Job No. 184041

Re: Response to:
Colorado Geological Survey Review Comments, dated June 29, 2022, and
El Paso County Planning and Community Development Comments, dated July 15, 2022.

SOILS AND GEOLOGY STUDY

**Phases 1-4, Falcon Highlands
El Paso County, Colorado**

FIG No. 22

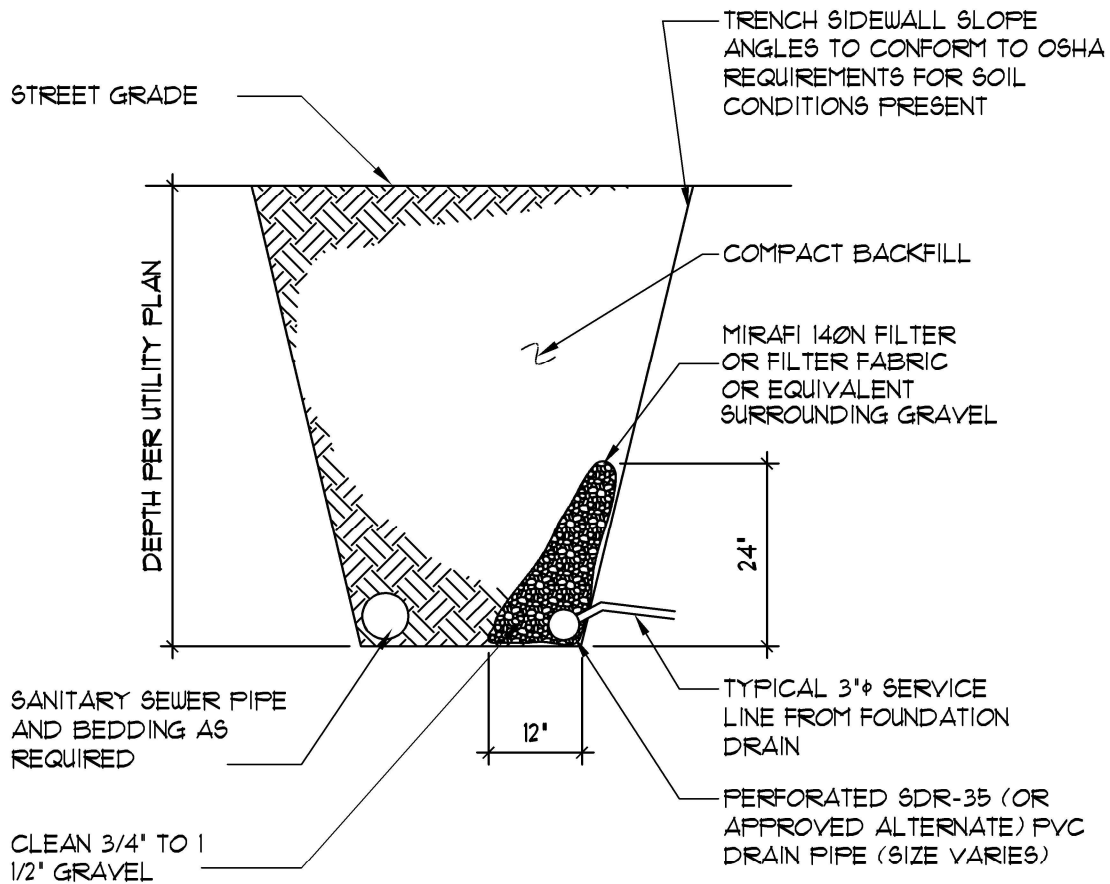
RMG states on p. 14, "If groundwater is encountered at the time of the site-specific subsurface soil investigations within 4 to 6 feet of the proposed basement slab elevation, an underslab drain would be considered in conjunction with the perimeter drain."

We agree with using an underslab drain should water be expected within 4 to 6 feet of the proposed basement slab elevation. However, site-specific subsurface soil investigations only provide a "snap-shot" of water levels. Groundwater measurements at the time of drilling, or even several weeks later, do not provide the necessary data to determine groundwater fluctuations. Discussion in the report should include the expected seasonal groundwater variation as part of the geologic description of the site. Monitoring groundwater levels through a complete spring-summer-fall-winter cycle remain the most reliable way to estimate from data the extent of seasonal fluctuations at a site.

Section 7.6 Ponding Water, Springs and Seasonal Groundwater within the Soils and Geology Study has been revised to include expanded discussions on seasonal groundwater variations.
